COUNCIL ASSESSMENT REPORT

Panel Reference	PPSSEC-110
DA Number	DA-2020/417
LGA	Bayside Council
Proposed Development	Construction of an industrial warehouse estate with associated site offices, hardstand and parking areas; tree and vegetation removal; landscaping works; and signage, operating 24 hours / 7 days
Street Address	77 Stephen Road (aka 9 Coal Pier Road) Banksmeadow
Applicant/Owner	Goodman Property Services (Aust) Pty Limited/ The Trust Company Limited
Date of DA lodgement	14 December 2020
Total number of Submissions Number of Unique Objections	<ul style="list-style-type: none"> Two (2) Submissions
Recommendation	Approval
Regional Development Criteria (Schedule 7 of the SEPP (State and Regional Development) 2011	Development with a CIV of \$47,300,708.00
List of all relevant s4.15(1)(a) matters	<ul style="list-style-type: none"> Environmental Planning & Assessment Act 1979, Part 4 – Development Assessment & Schedule 7 of the SEPP- State and Regional Development 2011 which regional panels may be authorised to exercise consent authority functions of councils Environmental Planning & Assessment Regulation 2000, Part 6 – Procedures relating to Development Applications State Env

Figure. Two-way conflict

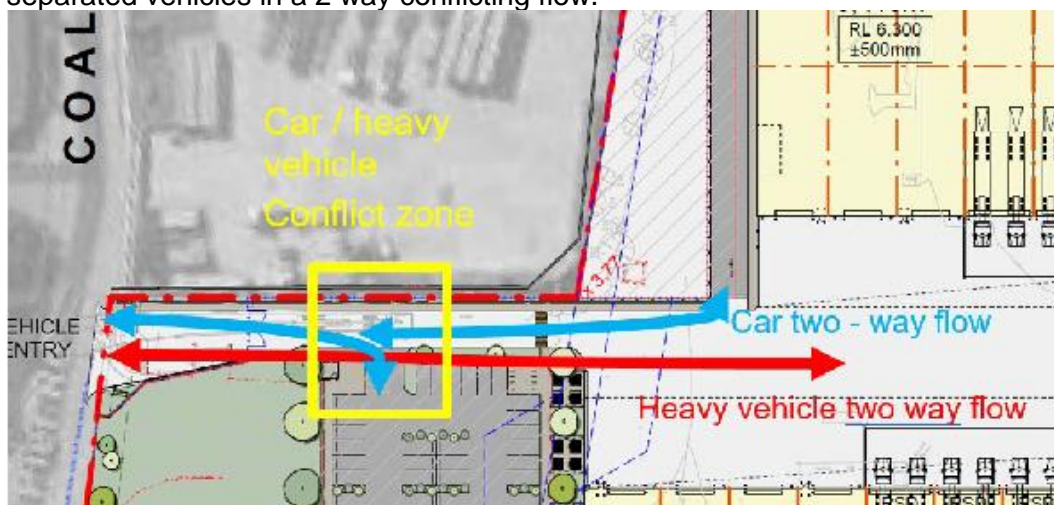
- While separated car and heavy vehicle access could theoretically be provided, it would still be necessary for cars to cross the heavy vehicle paths to access either the car parks for Warehouse A or B. This would remove any safety benefits from potential car / heavy vehicle separation (see Fig. 1 below).

- It is considered safer to have heavy vehicle and car movements sharing a common entry but move in a common direction rather than have a consolidated access way of separated vehicles in a 2 way conflicting flow.

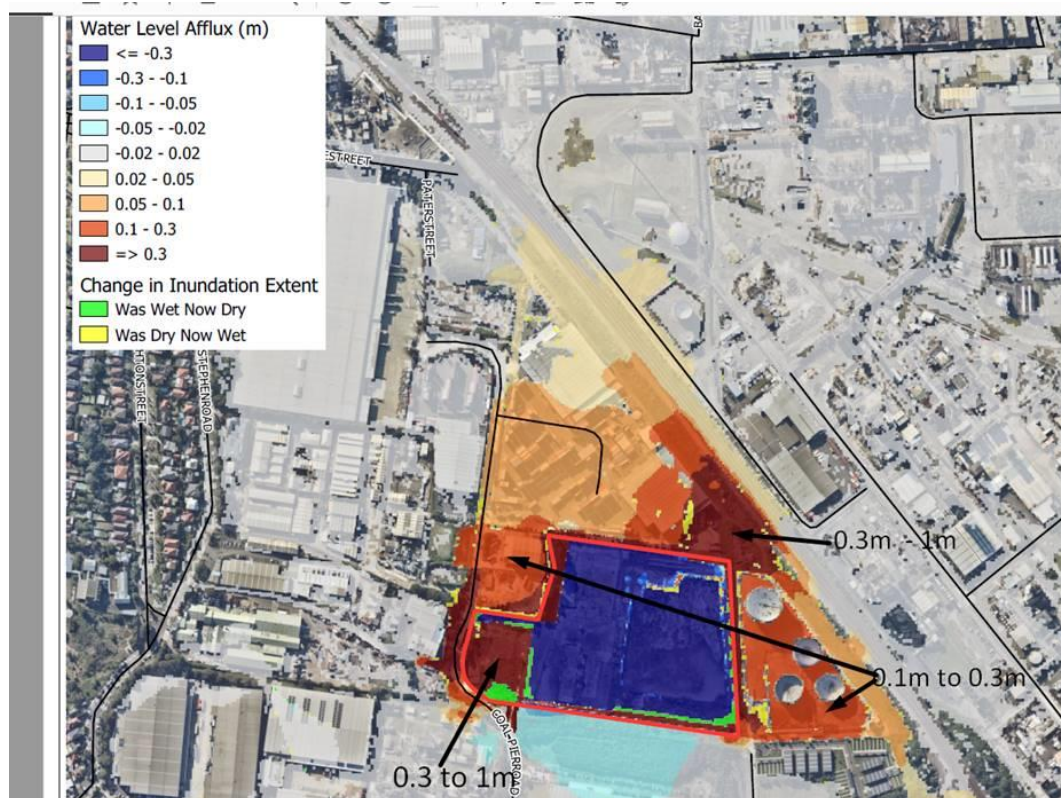
Councils Strategic Floodplain Engineer has reviewed the applicants Flood Assessment Report, Hazard Map and Probable Maximum Flood (PMF) Afflux Map for the proposed development. Initially, concerns were raised that the documentation did not adequately address the PMF across the site and the impacts of the additional fill relating to flooding onto the neighbouring properties. The applicant provided the abovementioned reports in addition to commentary relating to the proposal. While flooding and PMF is a relevant clause within the draft Bayside LEP 2021, the site is the Three Ports SEPP 2013 where there is no valid consideration of flooding within the SEPP. Regardless, the applicant has provided the information to demonstrate that there is no detrimental impact on environmental functions and processes on neighbouring properties.

The revised documentation shows localised flood level increase. PMF hazard map in developed case indicated that flood hazard in the adjoining sites (as shown in red marked figure below) will increase from H1 to H2. This is considered negligible as surrounding land uses are industrial in nature.
